GREEN ACRES SUBDIVISION REPLAT A

City of El Paso — City Plan Commission — 5/17/2018

SUSU18-00035 — Resubdivision Combination

ATTACHMENT 3

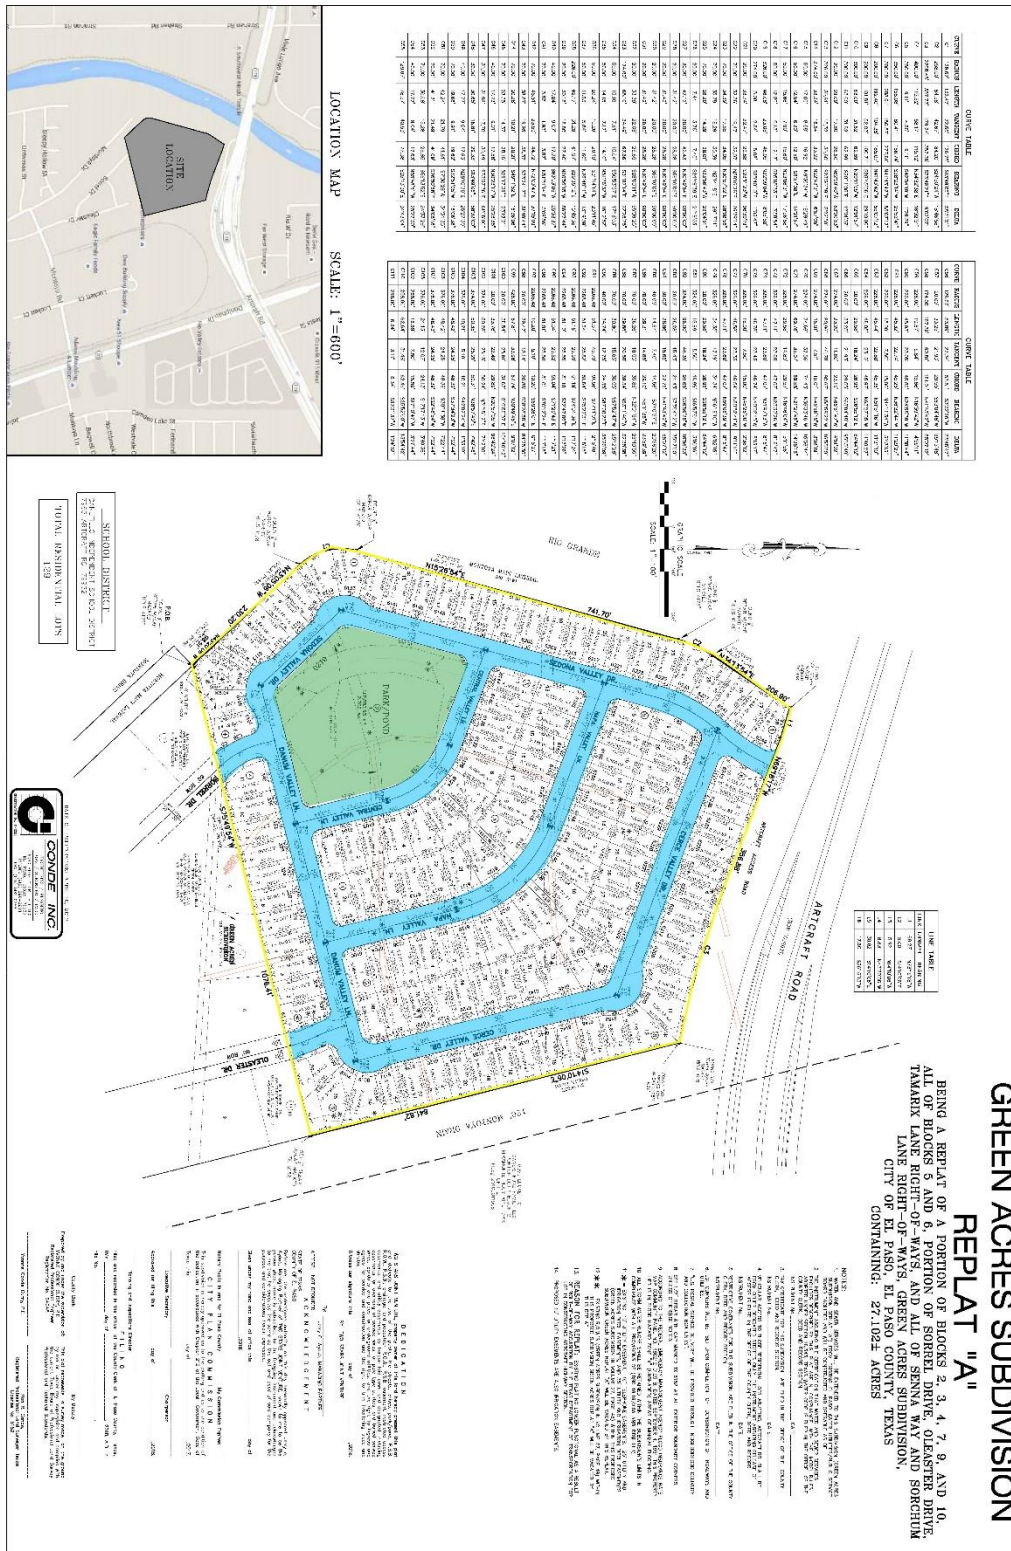
The applicant is requesting the following exception to exceed the maximum block perimeter for Blocks 1 and 6 as per Section 19.15.080 (Street length):

- o Block perimeter for Block 1 exceeds the maximum requirement by approximately 308 feet.
- o Block perimeter for Block 6 exceeds the maximum requirement by approximately 816 feet.

Planning staff recommends denial. The applicant is pending coordination with El Paso County Water Improvement District No. 1 (EPCWID).

1. The Park-Pond design shall comply with Parks, PSB, and City Code guidelines at time of subdivision improvement plans design review. Failure to comply may require the applicant to seek re-approval of the plat from CPC.

Also, please note that this Subdivision is composed of **129** Single-family dwelling lots and applicant is proposing to dedicate a **2.706 Acre Park/Pond**; affirmative recommendation by the director of the Parks Department is subject to the following:

1. A minimum of 0.50 acres of flat area (at curb level elevation) needs to be provided which shall not be subject to periodic inundation (10 year storm frequency) for installation of minimum improvements as required per Section 19.20.050(B)

2. A minimum of 17' wide flat perimeter area needs to be provided all along the rim/ pond perimeter to accommodate a 5' parkway for street trees, a meandering 7' wide concrete sidewalk and a 5' planted buffer zone.

3. Proposed Pond area slope next to the flat area not subject to periodic inundation needs to be maximum 12% or 8.5(H):1(V) so as to not to trigger the DSC 6' high rock wall fencing requirement.

4. All other Pond area slopes not abutting the flat area not subject to periodic inundation need to be maximum 6(H):1(V) so as to not to trigger the DSC 6' high rock wall fencing requirement.

5. A 5' wide ADA "Pedestrian" access (concrete sidewalk) shall be provided from the top of the flat area not subject to periodic inundation to the bottom of the pond area with-out hand railing.

6. Pond depth needs to be 4 feet maximum or half the depth from proposed top of street pavement and existing top of ground water table elevation - Provide written depth confirmation by independent soils lab.

7. Usable park area at the bottom of the Pond shall be large enough for practice fields; no less than 35,000 Sq. Ft. or 0.80 acres.
8. A 15' wide concrete vehicular access ramp at maximum 12% slope shall be provided to the bottom of the Park / Pond area.

9. Park / Pond design concept also needs approval from City Flood Plain Administrator (Land Development Dept.) and EPWU Storm Water Division.
10. Provide 15' wide "Pedestrian Access" to the east & west sides of the development to provide access to the Montoya Main Lateral/River levee & the 120' Montoya Drain.
11. Covenants need to be provided restricting the use to a single family dwelling unit per lot since zoning allows for Multi-family.
